DRAWING NO <b>C2.0</b>	JOB TITLE LOT 10 UNIT 1 RIVER MEADOWS SUBDIVISION TETON COUNTY, WYOMING	DRAWING TITLE FINAL SITE PLAN	<div> <div><b>NELSON</b></div> <div><b>ENGINEERING</b></div> <div>P.O. BOX 1599, JACKSON WYOMING (307) 733-2087</div> </div>	DATE	5/10/2019	REV.
	JOB NO <b>18-336-01</b>			SURVEYED	NE	6-13-19
			ENGINEERED	DD	8-28-19	
			DRAWN	DB		
			CHECKED	DD		
			APPROVED	DD

DRAWING NO	JOB NO	JOB TITLE	DRAWING TITLE	REV.				
				DATE	5/10/2019	NE	6-13-19	8-28-19
C3.0		LOT 10 UNIT 1	GRADING & EROSION CONTROL PLAN	SURVEYED	DD	DD	DD	DD
		RIVER MEADOWS SUBDIVISION	& UTILITY PLAN	ENGINEERED	DD	DD	DD	DD
		TETON COUNTY, WYOMING		DRAWN	DD	DD	DD	DD
	18-336-01			CHECKED	DD	DD	DD	DD
				APPROVED	DD	DD	DD	DD

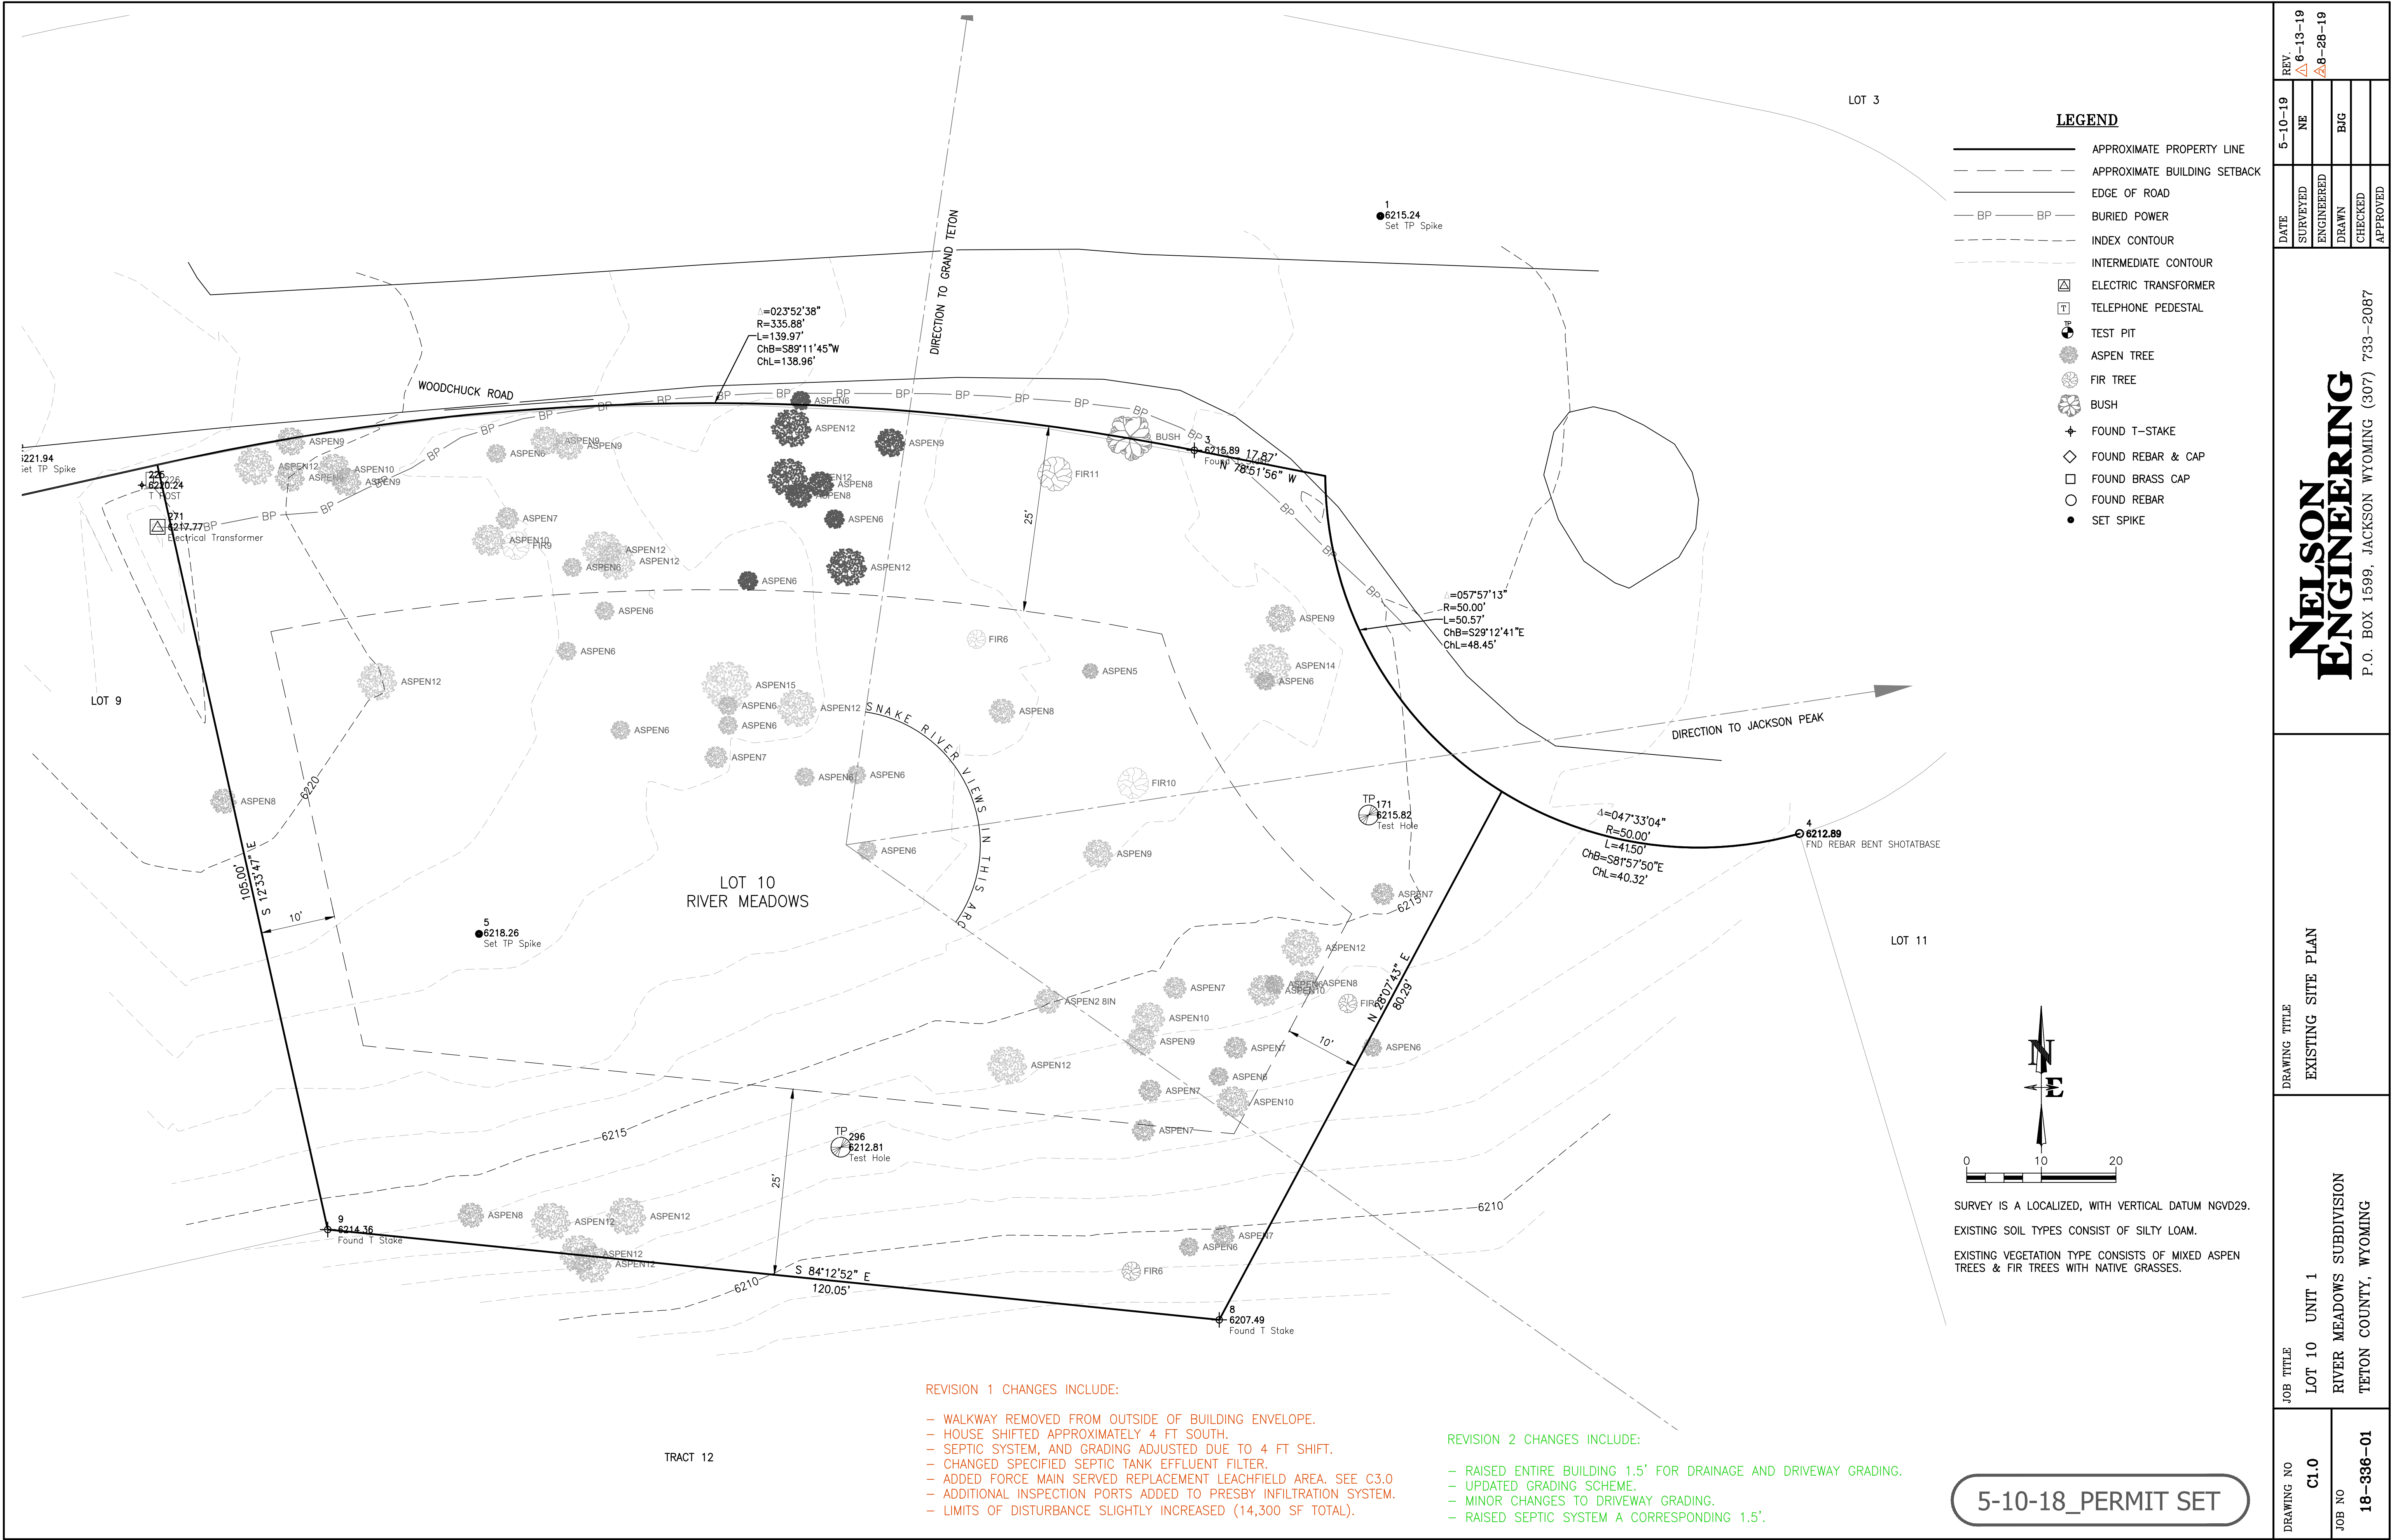
- WALKWAY REMOVED FROM OUTSIDE OF BUILDING ENVELOPE.
- HOUSE SHIFTED APPROXIMATELY 4 FT SOUTH.
- SEPTIC SYSTEM, AND GRADING ADJUSTED DUE TO 4 FT SHIFT.
- CHANGED SPECIFIED SEPTIC TANK EFFLUENT FILTER.
- ADDED FORCE MAIN SERVED REPLACEMENT LEACHFIELD AREA. SEE C3.0
- ADDITIONAL INSPECTION PORTS ADDED TO PRESBY INFILTRATION SYSTEM.
- LIMITS OF DISTURBANCE SLIGHTLY INCREASED (14,300 SF TOTAL).

- RAISED ENTIRE BUILDING 1.5' FOR DRAINAGE AND DRIVEWAY GRADING.
- UPDATED GRADING SCHEME.
- MINOR CHANGES TO DRIVEWAY GRADING.
- RAISED SEPTIC SYSTEM A CORRESPONDING 1.5'.

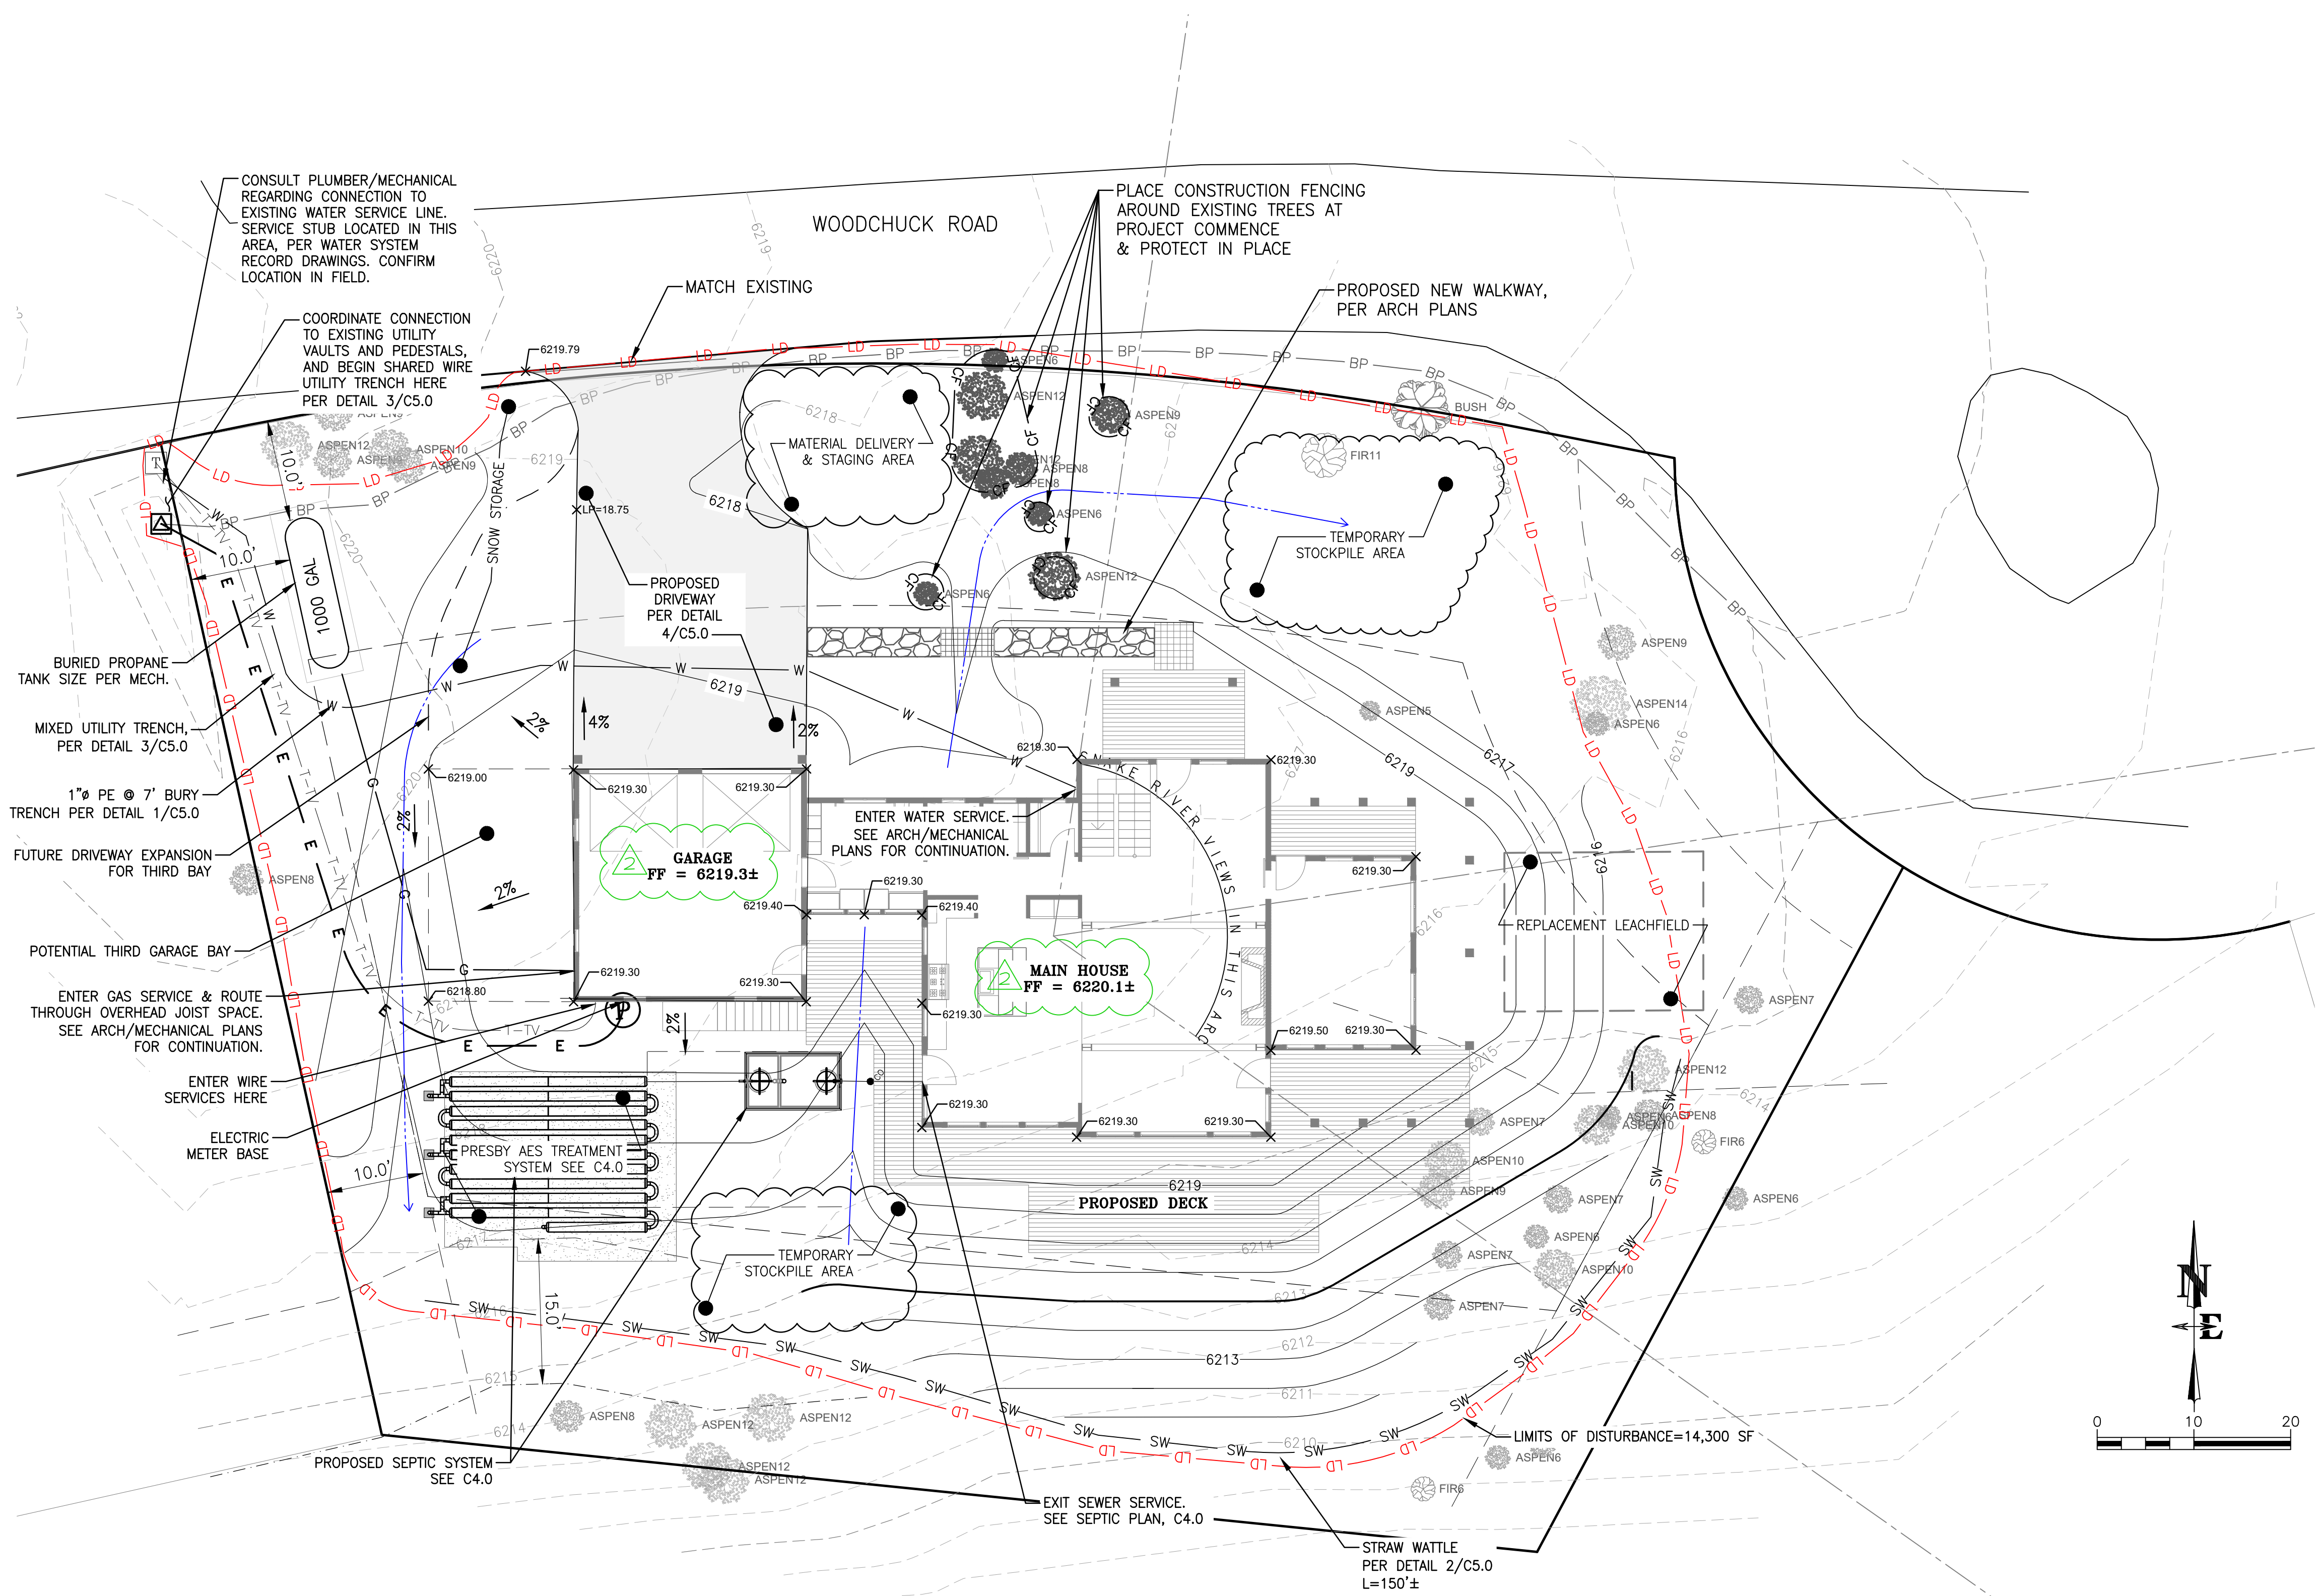
REVISION 1 CHANGES INCLUDE:

- WALKWAY REMOVED FROM OUTSIDE OF BUILDING ENVELOPE.
- HOUSE SHIFTED APPROXIMATELY 4 FT SOUTH.
- SEPTIC SYSTEM, AND GRADING ADJUSTED DUE TO 4 FT SHIFT.
- CHANGED SPECIFIED SEPTIC TANK EFFLUENT FILTER.
- ADDED FORCE MAIN SERVED REPLACEMENT LEACHFIELD AREA. SEE C3.0
- ADDITIONAL INSPECTION PORTS ADDED TO PRESBY INFILTRATION SYSTEM.
- LIMITS OF DISTURBANCE SLIGHTLY INCREASED (14,300 SF TOTAL).

REVISION 2 CHANGES INCLUDE:

- RAISED ENTIRE BUILDING 1.5' FOR DRAINAGE AND DRIVEWAY GRADING.
- UPDATED GRADING SCHEME.
- MINOR CHANGES TO DRIVEWAY GRADING.
- RAISED SEPTIC SYSTEM A CORRESPONDING 1.5'.
